Proposed South East facing Elevation - Vivary Cottage

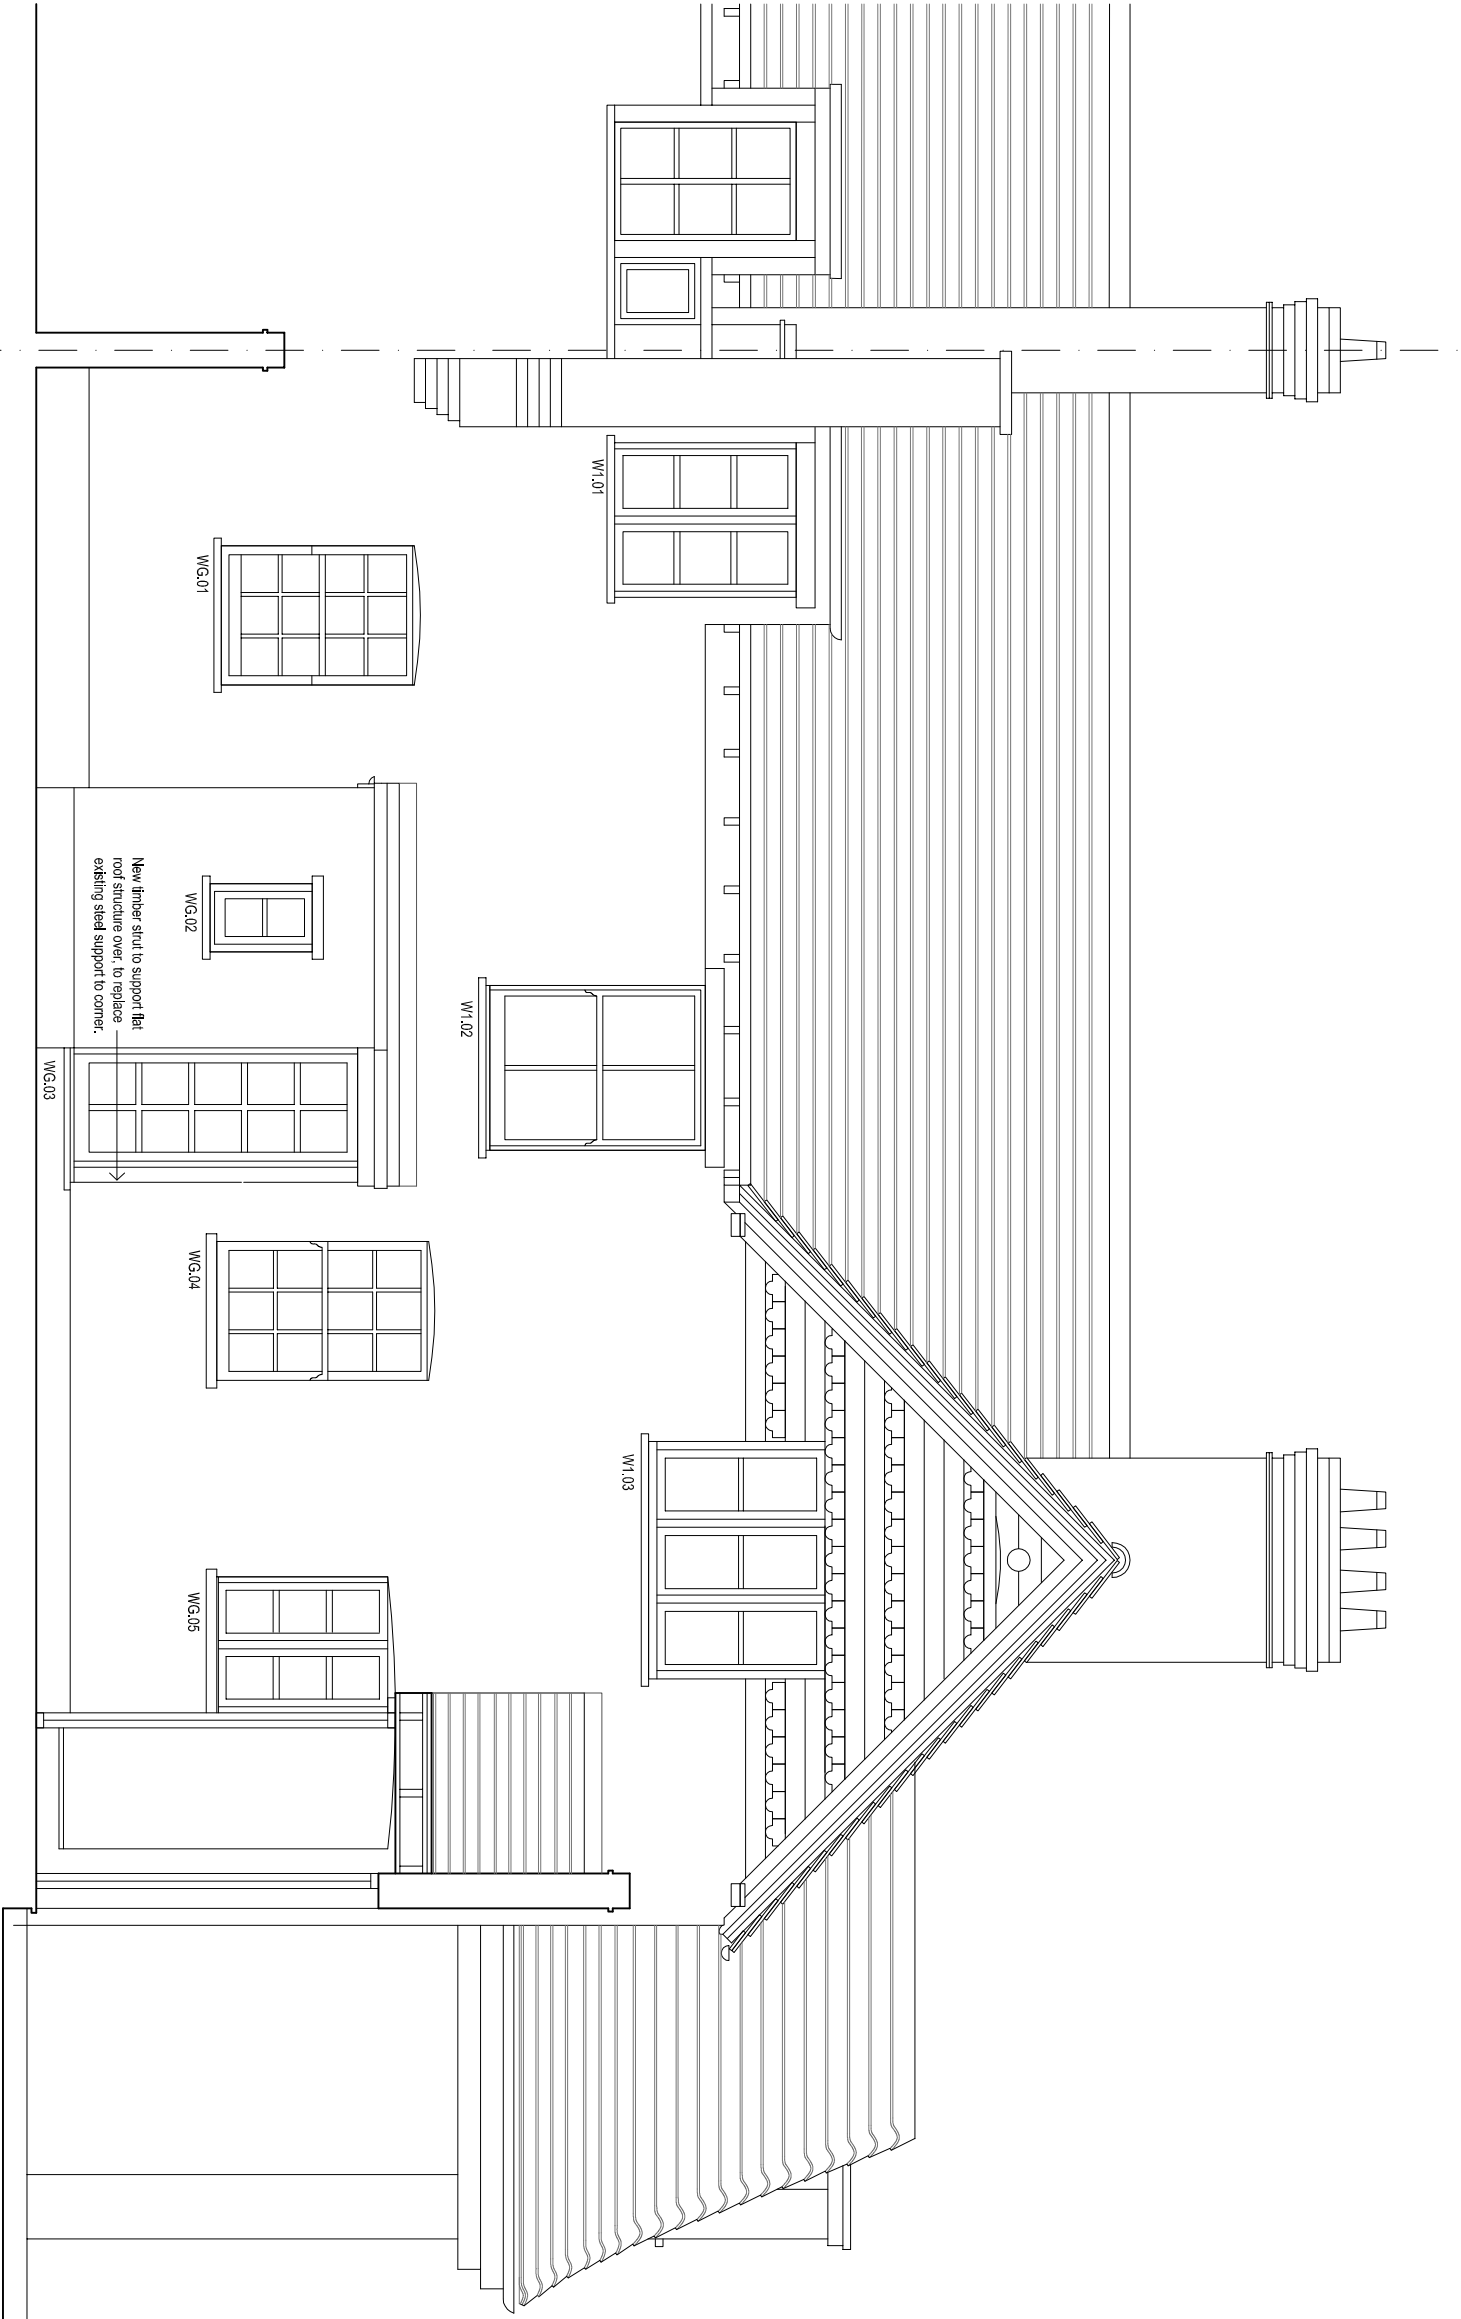
A. Proposed windows to be single glazed. WG.03 altered. 17/04/17

New high performance felt roof finish to rear flat roofed extension with furrings altered to ensure adequate fall.  
New clear single glazed timber windows to WG.05 and W1.01 to match detail of existing timber window W1.06 but with reveal to accommodate 4mm clear, single glazing. WG.02, WG.03 and W1.03 to match details as above but to be obscure glazed with Pilkington Arctic or equal approved. See details D01 and D02.  
WG.03 requires new timber strut to support roof timbers to replace existing steel strut at corner.
